RE: **Final Scope**
American Museum of Natural History
Richard Gilder Center for Science, Education, and Innovation
CEQR No. 16DPR004M
SEQR Classification: Type I
Project area: The west side of the American Museum of Natural History complex and Theodore Roosevelt Park located on the superblock bounded by West 81st Street, West 77th Street, Central Park West, and Columbus Avenue Community District #7

Response to Comments on the Draft Scope of Work

Proposed Site Plan
Figure 4

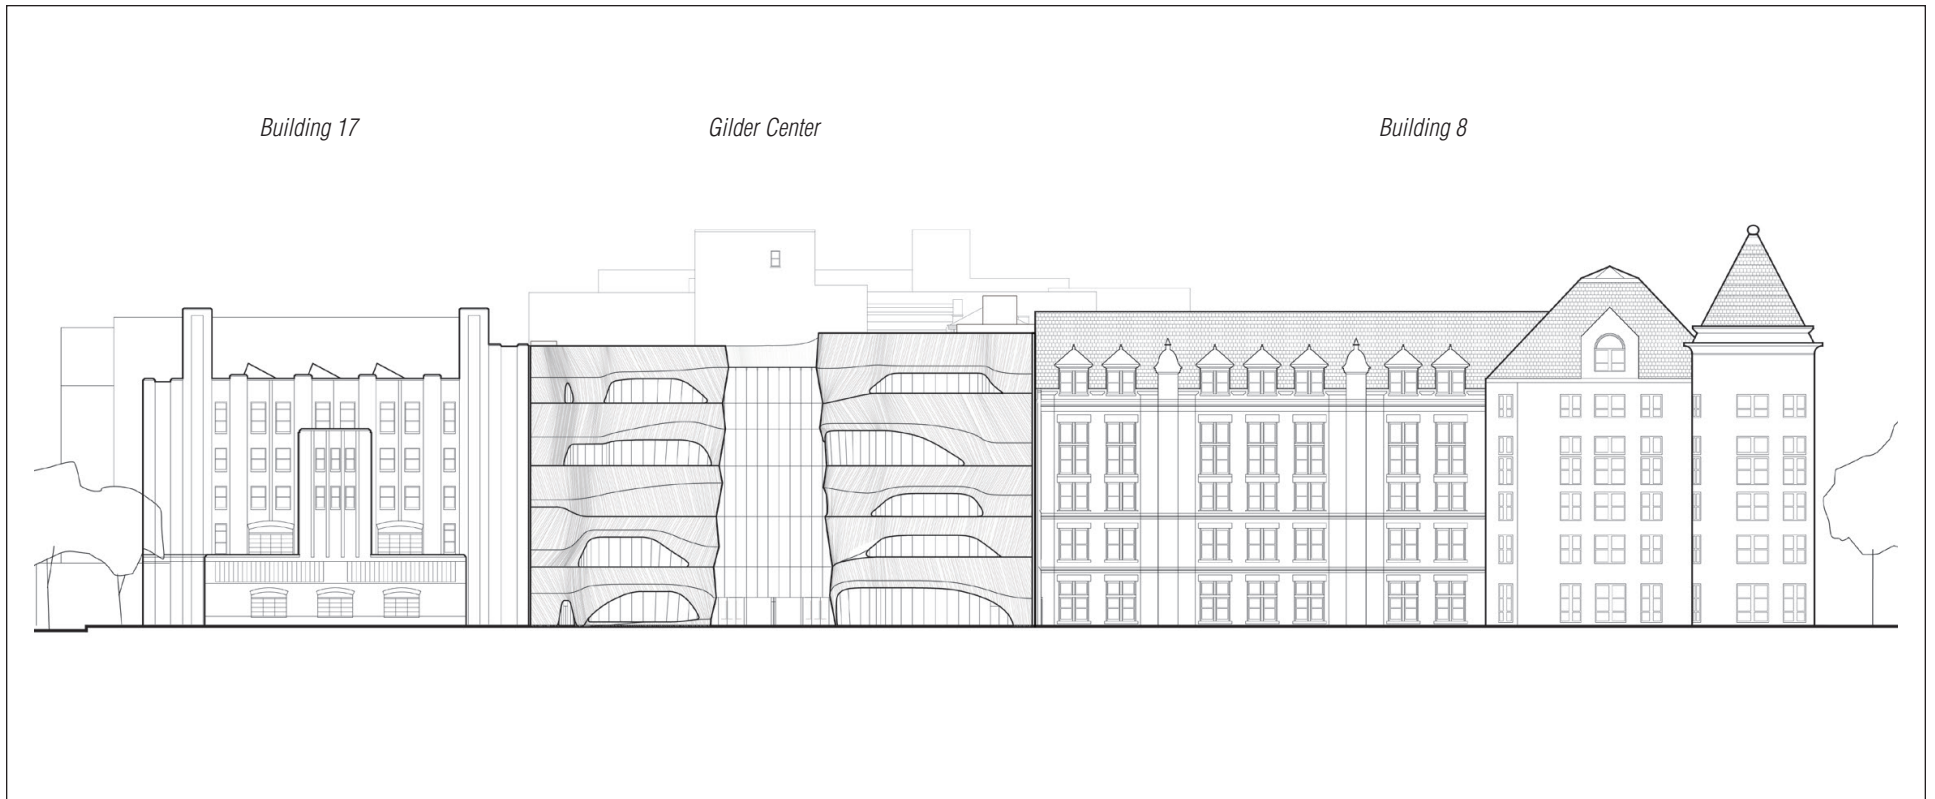
Comment 9: The draft scope almost entirely neglects the proposed construction of an underground service driveway running from 78th Street to the Gilder Center. The draft simply says “service areas...would be replaced or improved.” In fact, AMNH originally proposed a driveway excavation that would remove two mature canopy trees—a majestic English Elm and a Pin Oak—with trunks more than two feet in diameter. After we raised concerns, AMNH is now considering possible revision in the driveway layout that could save one or both of the trees. The scope should assure that the EIS pursues this mitigation. (Browser [Alliance]_040, DefendersTRP_007, Kaufman [Alliance]_042, Pierpont_050, Smith [DefendersTRP]_020, Steinberg_022)

The draft scope does not provide adequate description of either the present site or the proposed project. The scope says that the development area includes the Weston Pavilion and two other Museum buildings, but these other buildings are never identified. (Dwyer_097)

Response: Subsequent to the publication of the Draft Scope of Work, and as reflected in the Final Scope, the area of the proposed below-grade service area was reduced and the design of the service drive was modified with the goal of preserving two trees. AMNH is developing plans to protect and conserve these two trees, an English elm and a Pin oak. The Project Description of the DEIS will provide a description of the design and programming of any changes to the service driveway, as well as all other subsurface work. The impact of such elements will be assessed in the DEIS. The purpose and need for this component of the

Response: The response on page eight of the EAS refers to the number of buildings that would be constructed by the proposed project, not the number of buildings that would be removed. The project would involve the removal of three existing buildings and construction of one new building. The Draft Scope provided a sufficient level of detail for purposes of identifying the environmental issues and methodologies for CEQR review, and for public review of the proposed methodology. It is customary for projects to evolve during the review process, particularly during the earlier stages of review such as scoping. The building site is defined and shown on the proposed site plan—see Scope Figure 4.
